Proposal for amendments to global technical regulation No. 9 (Pedestrian safety)

Submitted by the expert from the European Commission as Chair of the Task Force on Bumper Test Area within the Informal Working Group on global technical regulation No. 9, Phase 2 – Proposal of amendments to Proposal of amendments to ECE/TRANS/WP.29/GRSP/2015/2.

"Figure 5A

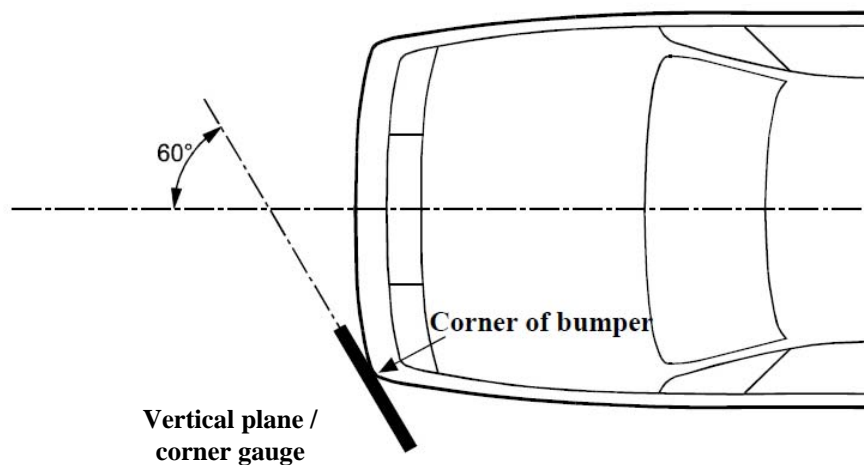
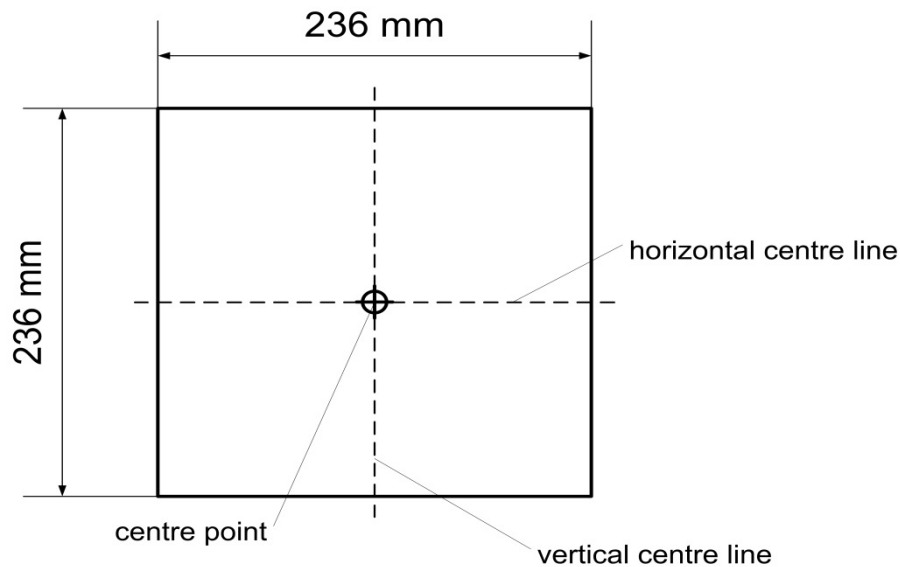
Figure 5, amend to read:

Corner of bumper example (see paragraph 3.14., note that the corner gauge is to be moved in vertical and horizontal directions to enable contact with the outer contour/front fascia of the vehicle)

Figure 5C
Determination of the corner of bumper with the corner gauge (shown in random location)

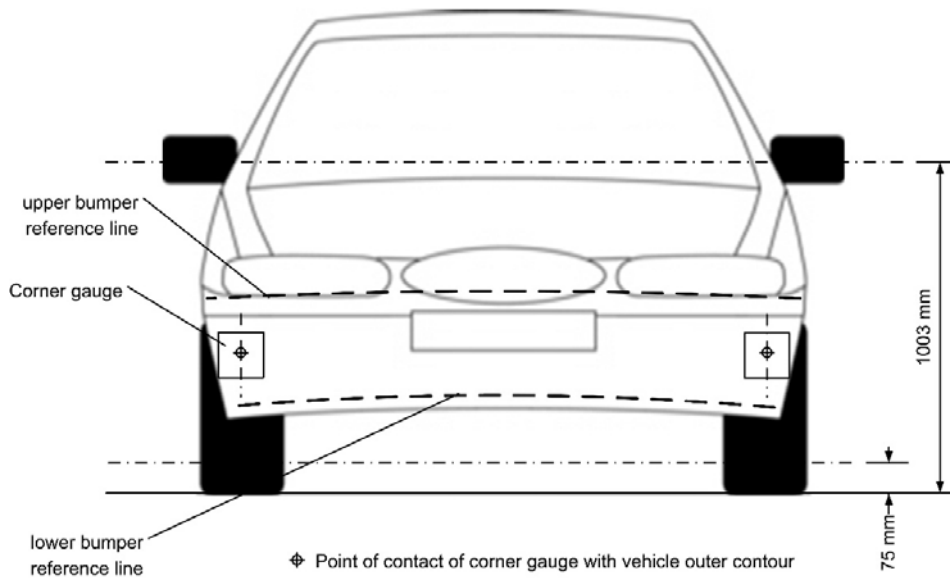
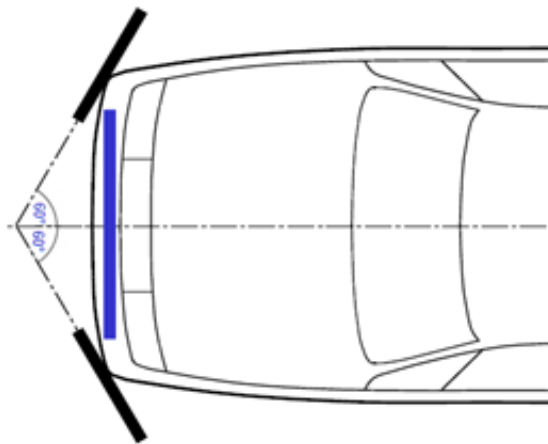
For determination of the corner of bumper, the front surface of the corner gauge is moved parallel to a vertical plane with an angle of 60° to the vertical longitudinal centre plane of the vehicle (see Figures 5A and 5C) at any height of the centre point of the corner gauge between:

For determination of the corner of bumper, the gauge is moved to contact the outer contour/front fascia of the vehicle touching at the vertical centre line of the gauge. The horizontal centre line of the gauge is kept parallel to the ground plane.
